Check the component list with FNAL solid model

Solid model of FNAL S1-G cavities

FNAL cavities and magnetic shieldings

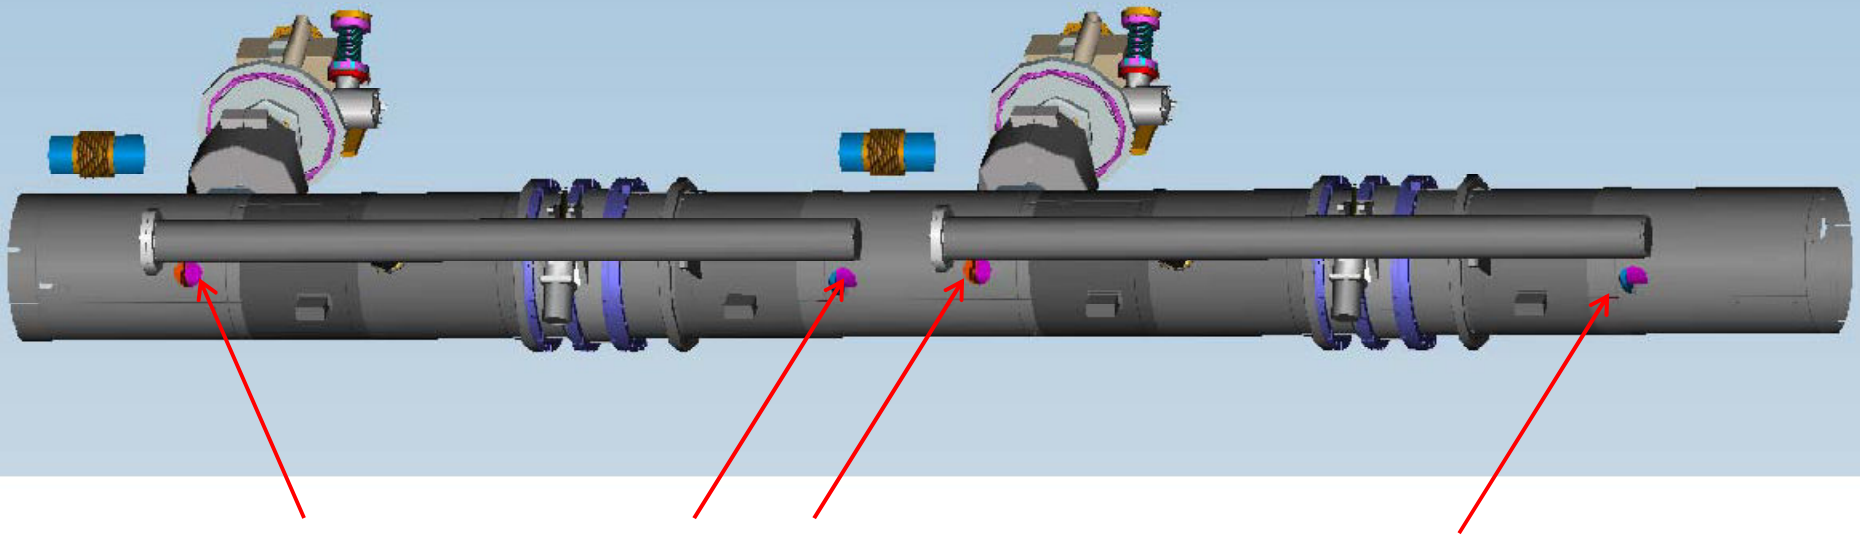
Holes on the shield plates
What is the function of the holes?

Cavity Packages

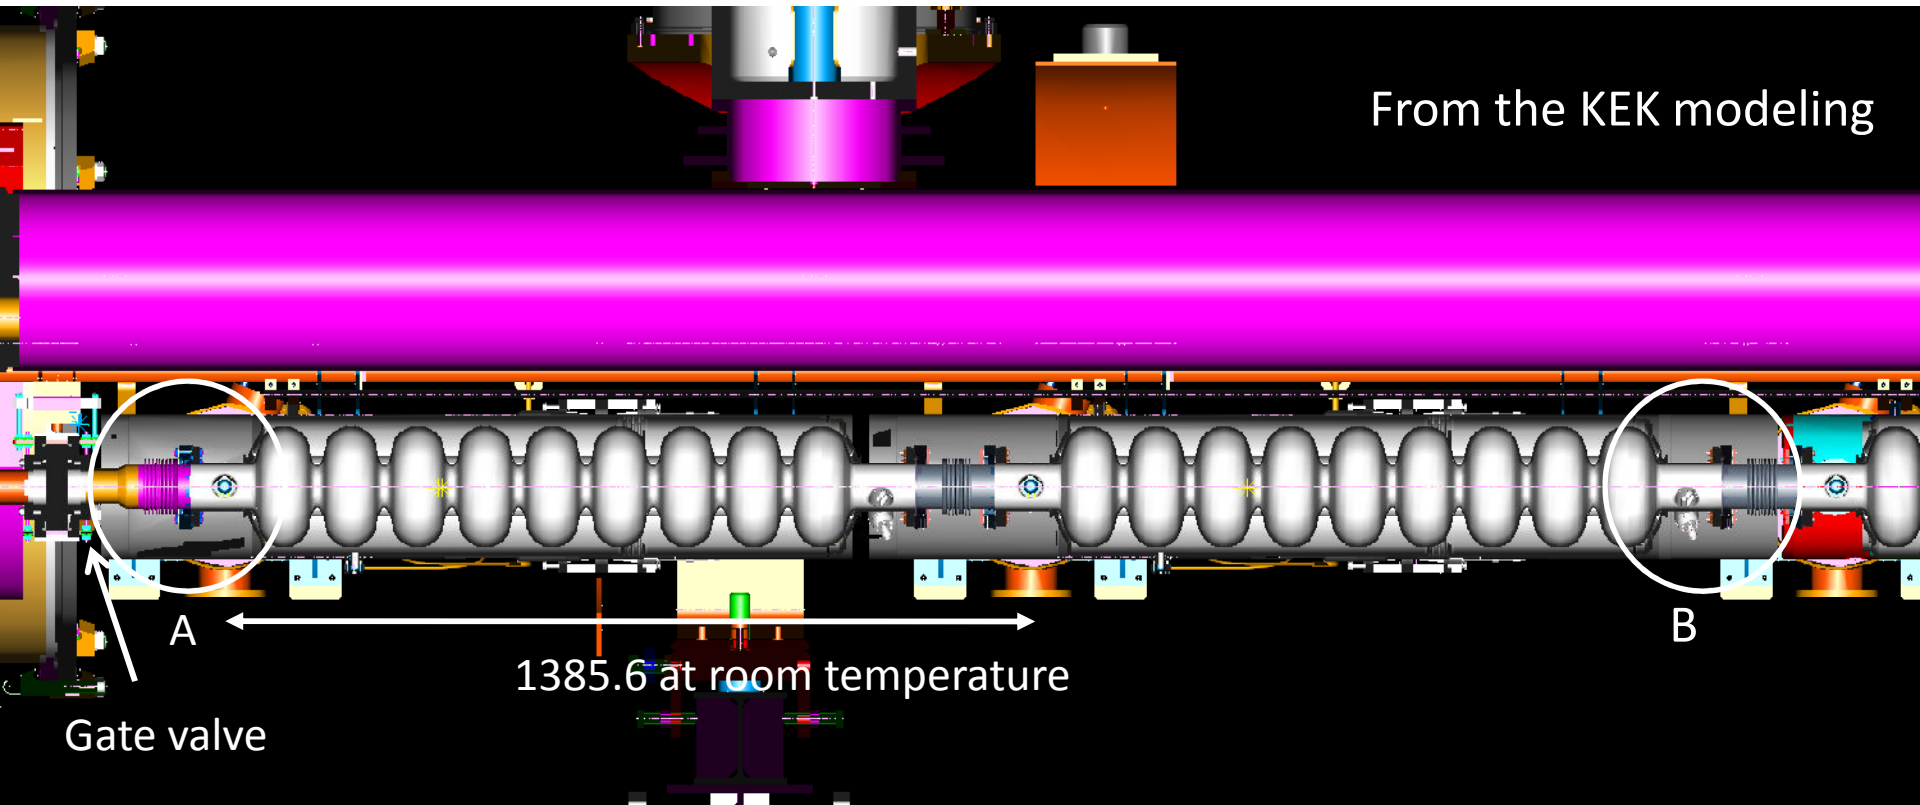
A: The present shield design by FNAL/Don has an interference with the gate valve. The length of the shield in the solid model by Don is 351.5 mm while the length might be 286.5mm.

B: The length of the FNAL shield is 351.5 mm. For overlapping to DESY shield, the length might be 231.5 mm.

The length between the input couplers is 1385.6 mm at room temperature. In the drawing by Don, the distance is 1385.15mm. Are the modeling made at cold temperature?

Input couplers

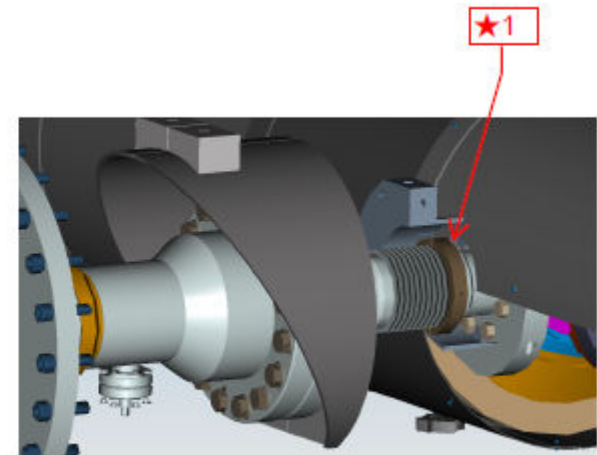
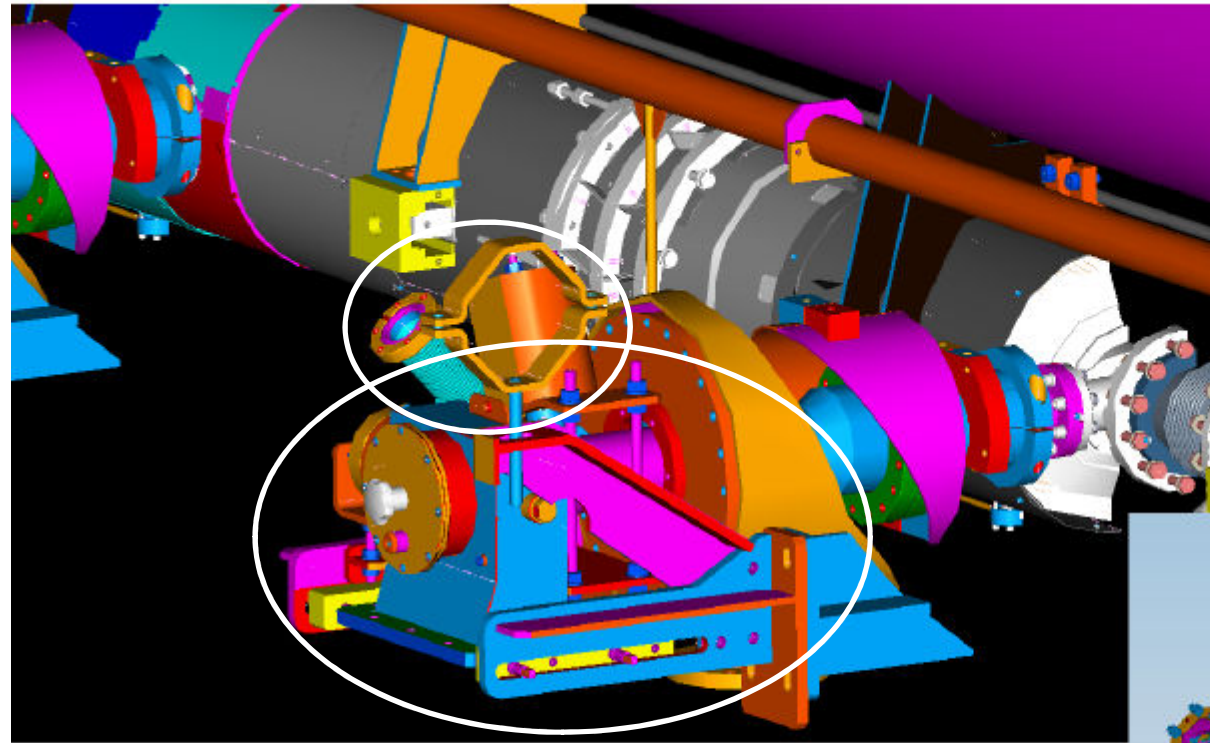
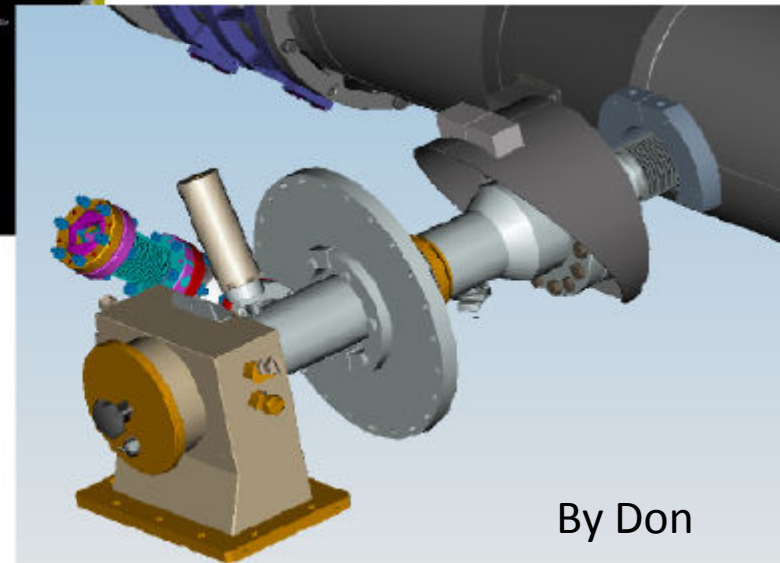
The enclosed components by white circles are required for assembling and supporting warm coupler and vacuum pipes. The hole on the shield has interference with the coupler components.
